TOWN OF GRAY
PLANNING BOARD
AGENDA • MAY 10, 2022

**Re: Major Site Plan, Minor Subdivision, and Conditional Use Permit application update
Lewiston Road Subdivision, Gray, Maine
Odessa Properties, LLC – Applicants**

The following response has been prepared based on the comments provided by Will Haskell from Gorrill Palmer in his review of the project materials in an email dated April 6, 2022. It should be noted that the review engineer was not in receipt of the stormwater plans during his initial review. While these plans were included in the initial submittal, as a separate additional file along with the project design plans, we did experience technical issues when sharing digital plans attached to emails with Town and take full responsibility for the review engineer not being able to have the stormwater plans during his review.

21062
JOB NUMBER:
1" = 40'
SCALE:
4-27-2022
DATE:
SHEET 3 OF 3
RPR-1

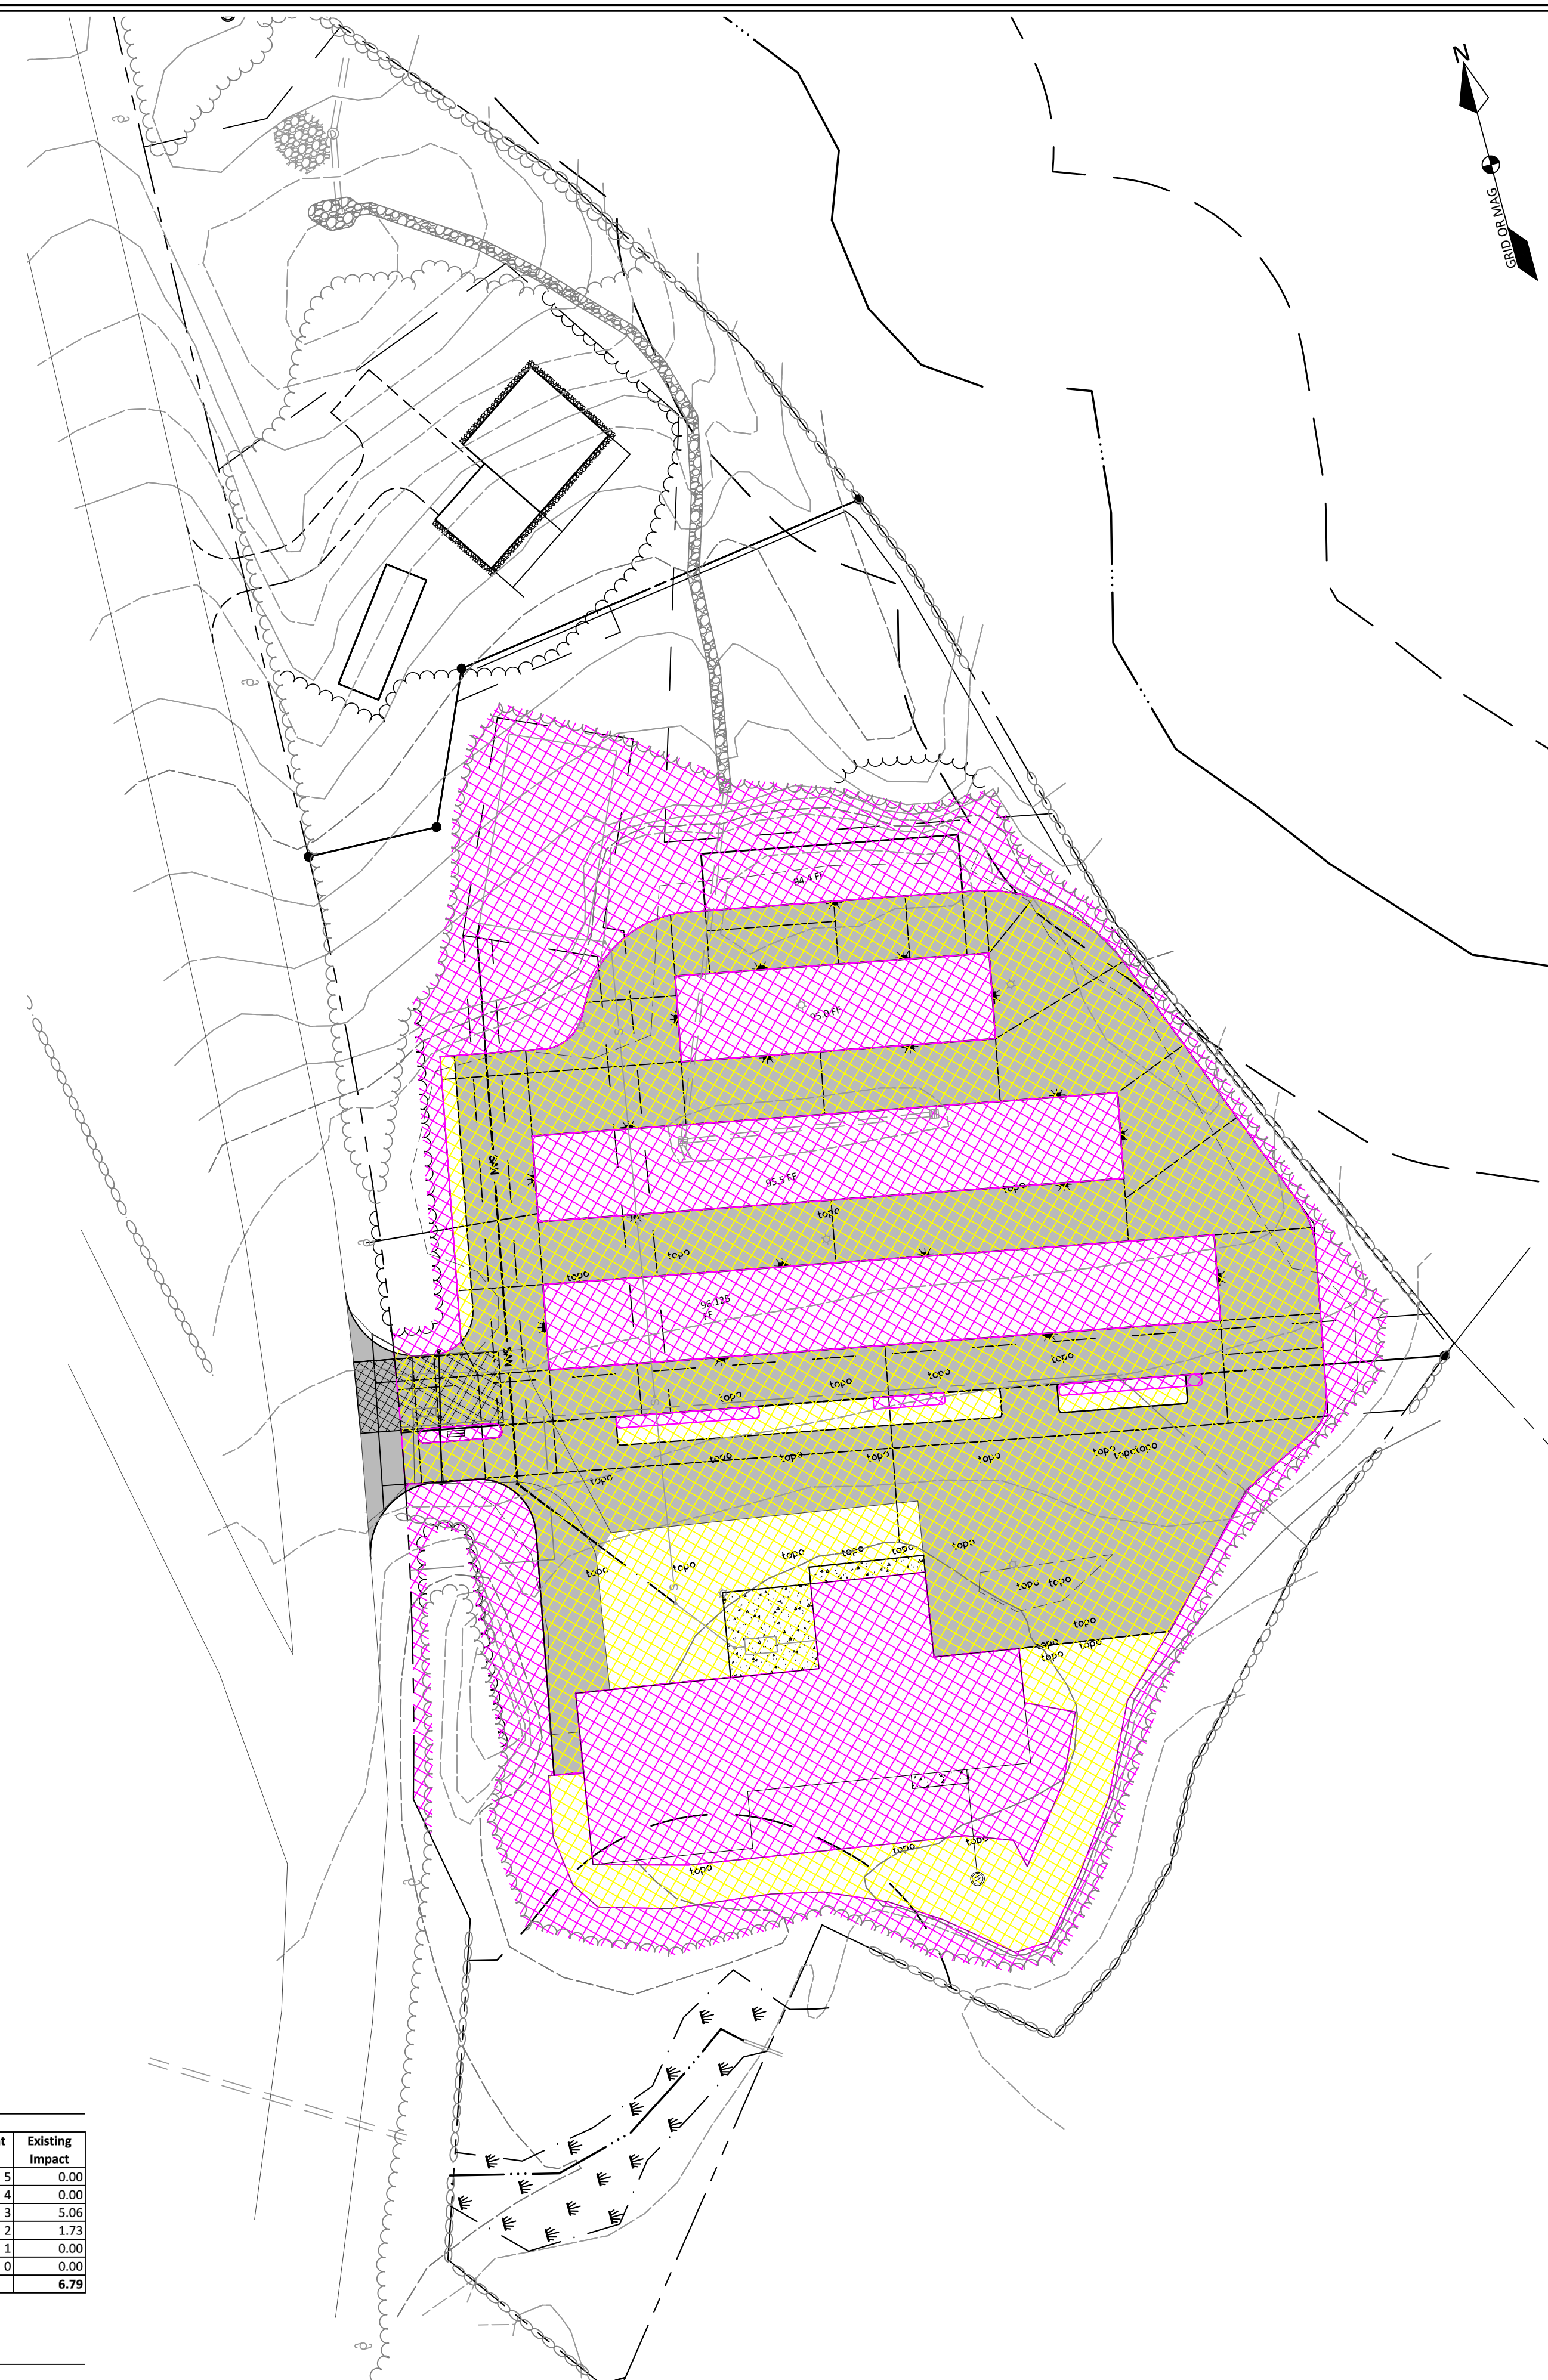
19. The total areas of the redevelopment calculations should be the same for the existing and proposed conditions. Provide a plan depicting the redevelopment areas used in the calculations.

Three stormwater plans have been included in the pdf along with the revised project design including the revised redevelopment plan. The revised redevelopment calculations show the same pre- and post-developed redevelopment area and are included on the Redevelopment Pollutant Ranking plan, sheet RPR-1.
